Process Sheet

Customer	: CU-DAR001 Dart Helicopters Services		Drawing Name	: BACK	
Job Number	: 25724		Part Number	: D32501	
Estimate Number	: 10879		Drawing Number	: D3250 REV B	
P.O. Number	: N/A		Project Number	: N/A	
This Issue	: 2/6/2006 S.O. No. : N/A		Drawing Revision	: B	
Prsh Rev.	: NC		Material	: N/A	
First Issue	: N/A Type : PURCHASED PARTS		Due Date	: 2/13/2006 Qty: 1 Um: Each	
Previous Run	: N/A				
Written By	: SEE COMMENT Below				
Checked & Approved By	: J				
Comment	: Est. B 04.10.26 D3250-1 no longer made in-house

DESIGN	DRAWN BY	DART AEROSPACE LTD HAWKESBURY, ONTARIO, CANADA	
CHECKED	APPROVED	DRAWING NO.	REV. C
06.02.01		D3250	SHEET 1 OF 1
DATE		TITLE	SCALE
06.02.01		BACK (DUAL BATTERY RACK)	1:6
A	04.04.06	NEW ISSUE	
B	04.11.04	20.625 WAS 20.243	
C	06.02.01	20.875 WAS 20.625, REMOVE Ø0.501 TOOLING HOLES

Subject: D205-579-015 Dual Battery Rack

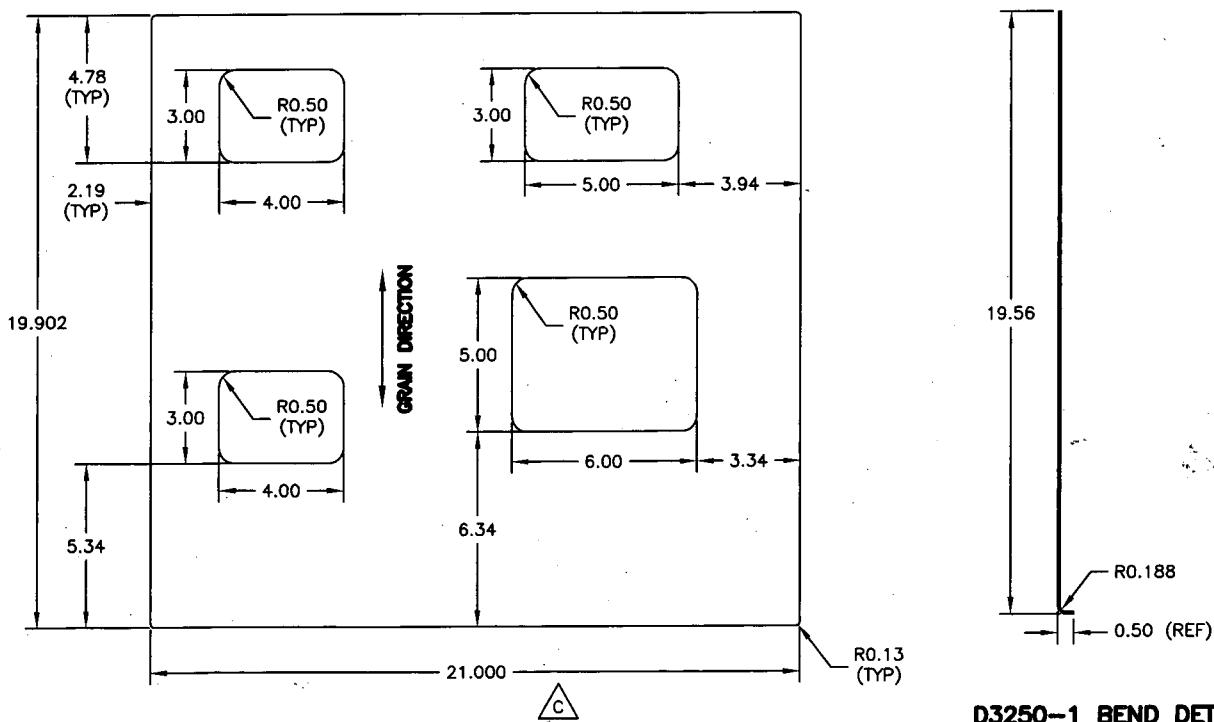
We revised above flat patterns to extend the width of our Dual Battery Racks from 20.75" to 21.25".
